ADMINISTRATIVE AMENDMENT

ADMINISTRATIVE AMENDMENT
FILE # ^{SI-2019} ~~20096~~ PROJECT # ^{PR-2019} ~~002284~~
Revised building
square footage.
PR-2019 03Apr2019
APPROVED BY _____ DATE _____

MULTI-USE RECREATIONAL
FACILITY, ALBUQUERQUE, NM

SITE PLAN

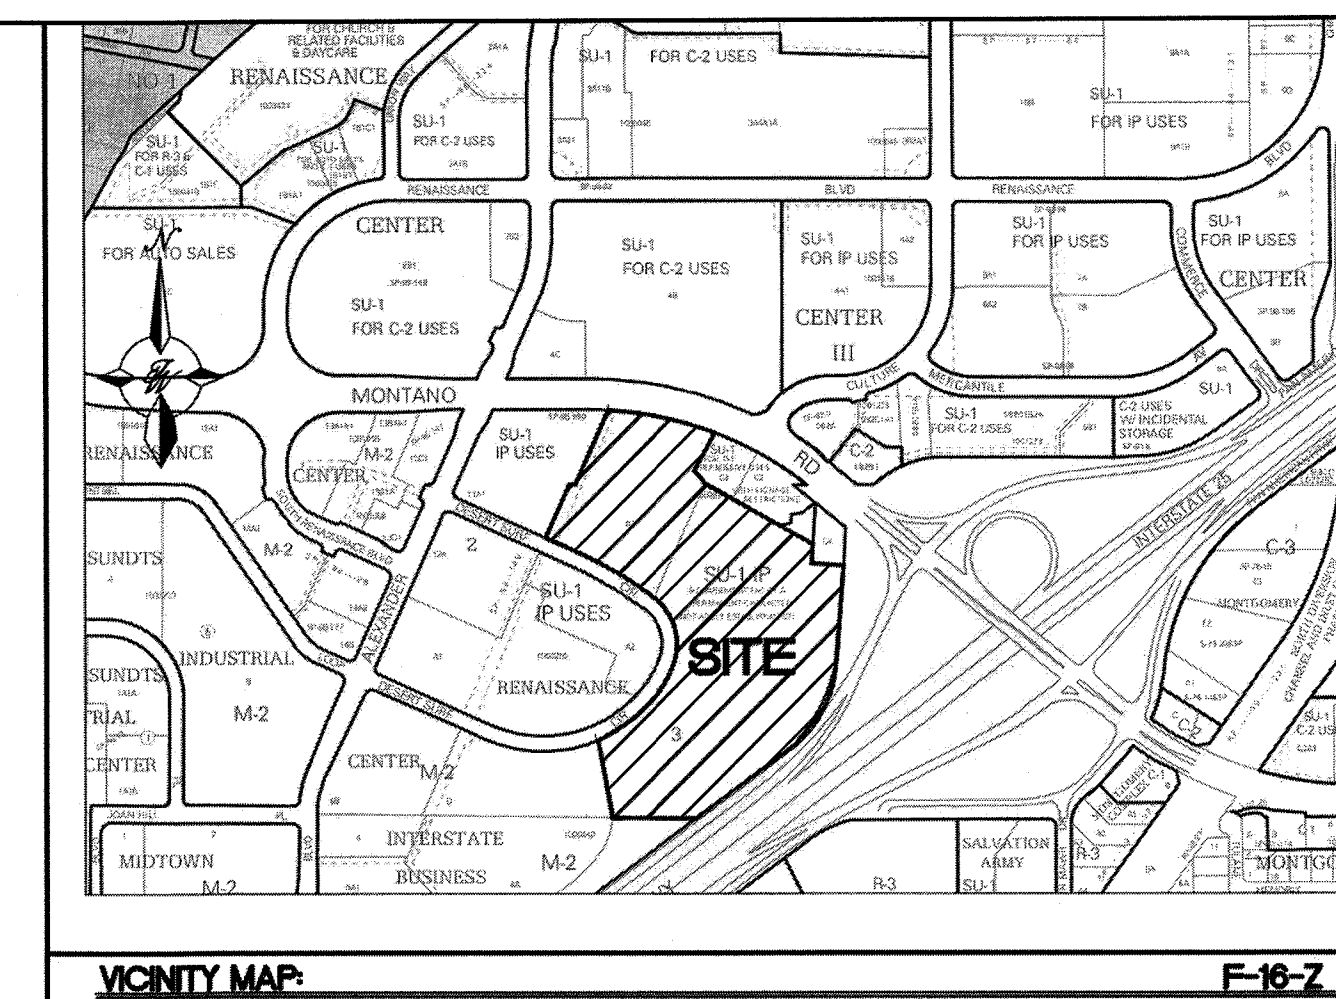
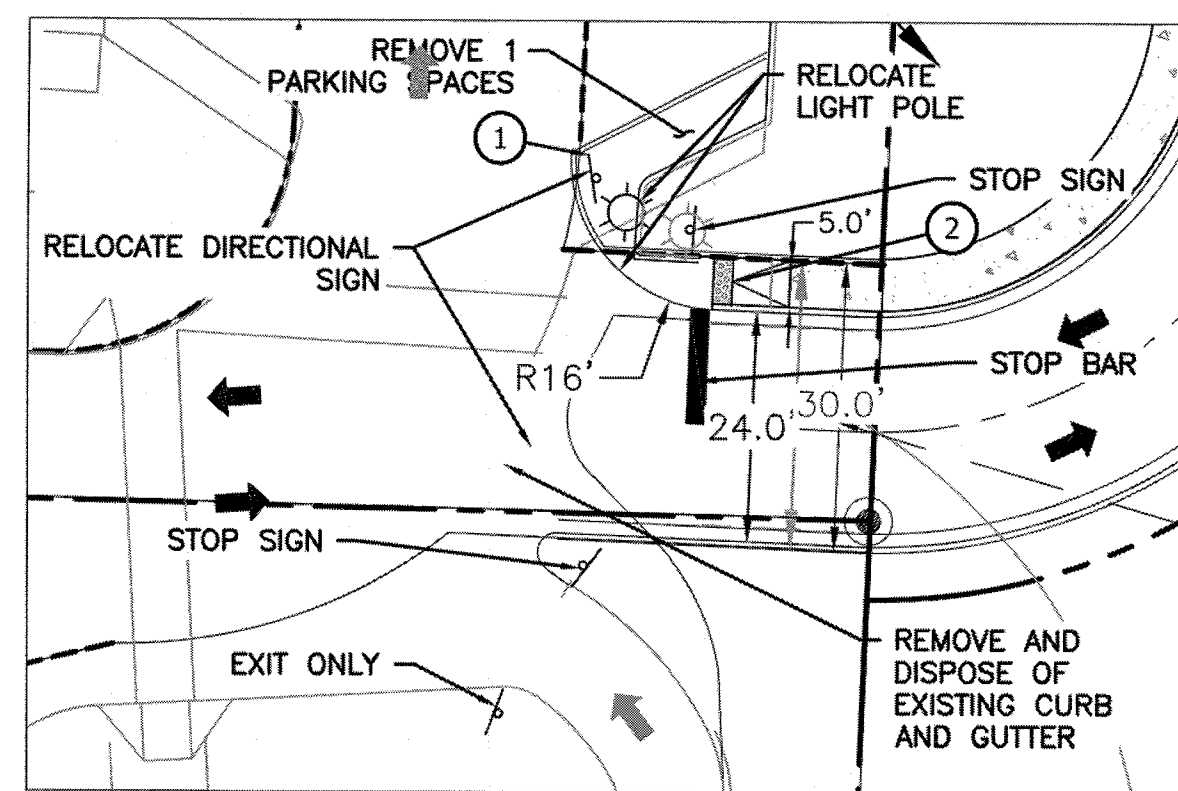
PROPOSED USAGE:	SU-1, IP & AMUSEMENT FACILITY OF A PERMANENT CHARACTER	20' DRAINAGE
LOT AREA:	612,771.94 SF (14.067 ACRE)	
BUILDING AREA:	48,295 SF	
FUTURE EXPANSION:	5,134 SF	
TOTAL FUTURE BUILDING AREA:	53,428	
PARKING REQUIRED:	75 SPACES (15,000 SF/1 SPACE PER 200 SF)	
<u>PARKING REQUIRED:</u>	<u>133 SPACES (31,222 SF/1 SPACE PER 250 SF)</u>	
TOTAL PARKING:	208 SPACES	
REQUIRED		
PARKING PROVIDED:	384 SPACES
